**In the Matter of:**  
**PR Spring Tar Sands Project**  
**February 15, 2011, Ground Water Discharge Permit-by-Rule**

**INDEX OF INITIAL RECORD**

**January 10, 2012**

**Figure 4c**  
**Earth Energy Resources Inc. - PR Spring Oil Sand Mine**  
**Longitudinal Mine Section N1-S1\* Rev.4**

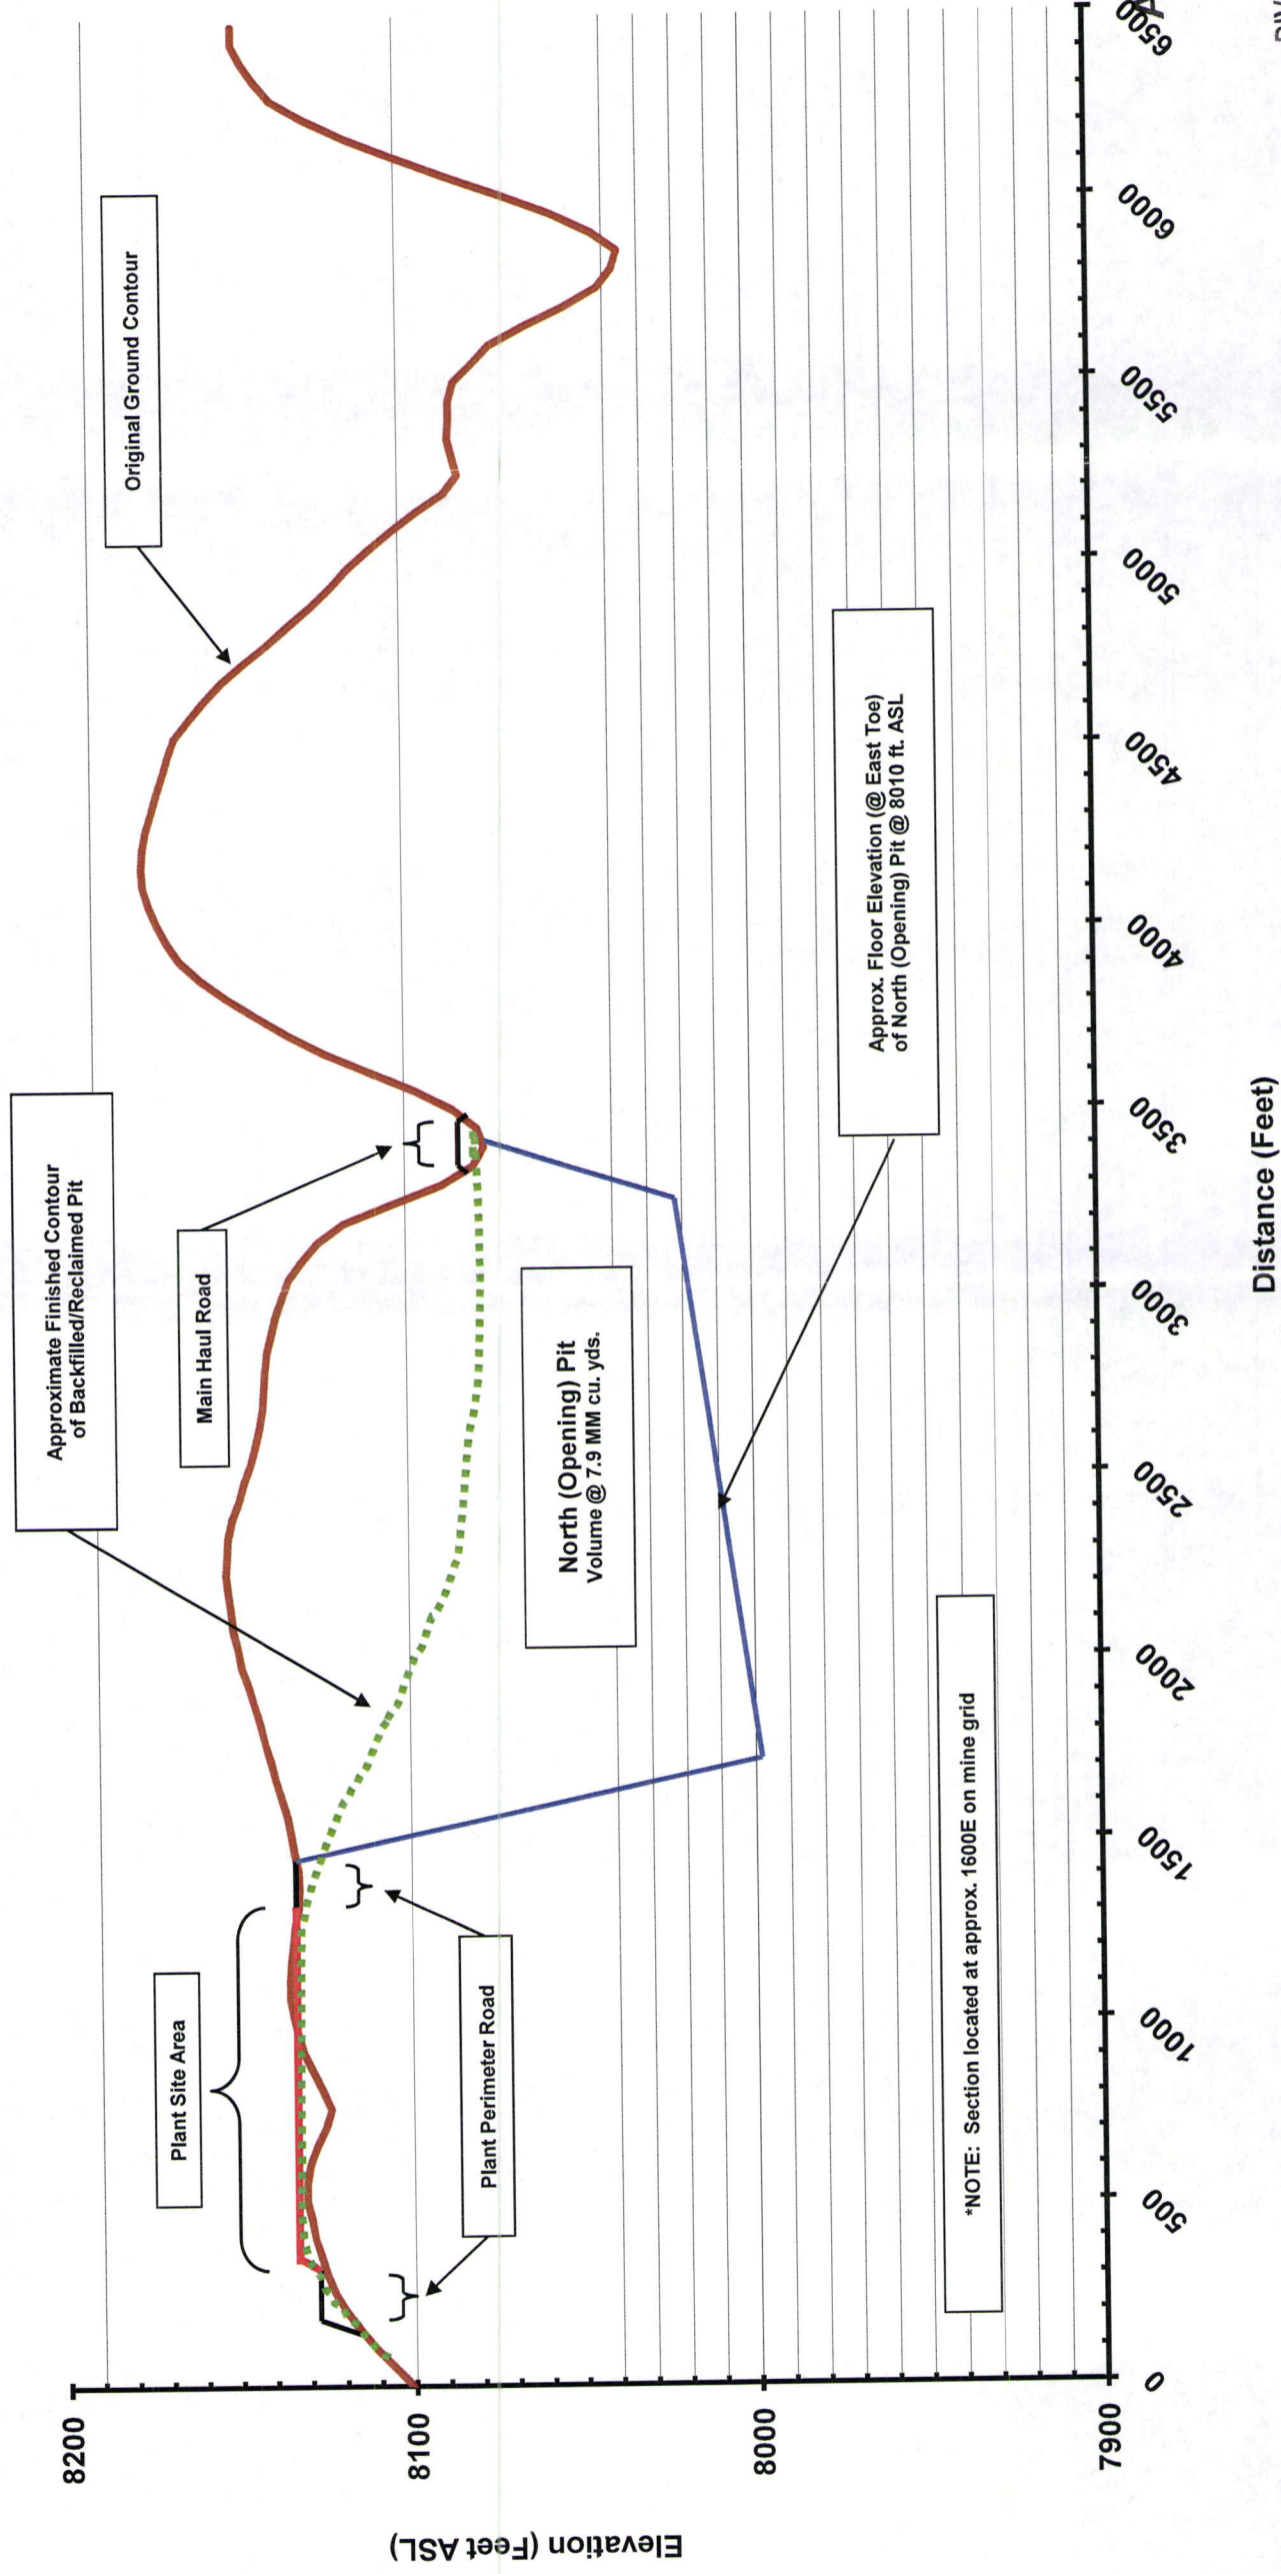
14	Figure 4a,4b,4c,6	FYI only, best if drawn with no vertical exaggeration, best if all x-sections are the same scale, engineering standards for drawing are lacking (lah)	A	Earth Energy respectfully disagrees that these cross sections are best shown without vertical exaggeration. Necessary detail would be lost if scales were equivalent, and vertical exaggeration is a standard practice to solve this problem. No changes to the scale of these drawings have been made.
15	Figure 4a,4b,4c	Slope angles shown on x-section are incorrect. (lah)	A	Earth Energy believes that the shown slope angles on all three of these figures are correct. Please note that a replacement for Figure 4b was submitted to the Division on May 15, 2008 to correct an error in the May 2008 2 <sup>nd</sup> draft NOI submittal.
16	Figure 5	As per 105.3.16 A geology map is required, include Geomechanical data; include orientation of bedding and structural features include faults, and joint sets orientations to demonstrate pit wall stability . (lah)	B	In response to a comment in the Division's Initial Review, the best available geologic map was provided as Figure 5 in the May 9, 2008 2 <sup>nd</sup> draft NOI. The response letter accompanying that 2 <sup>nd</sup> draft stated that it was the best available map. As requested by Comment # 40, generalized strike/dip information for bedding has been added to Figure 5. The other more detailed geologic information that the Division is requesting is simply not available, to Earth Energy's best knowledge, so it cannot be added to the map.
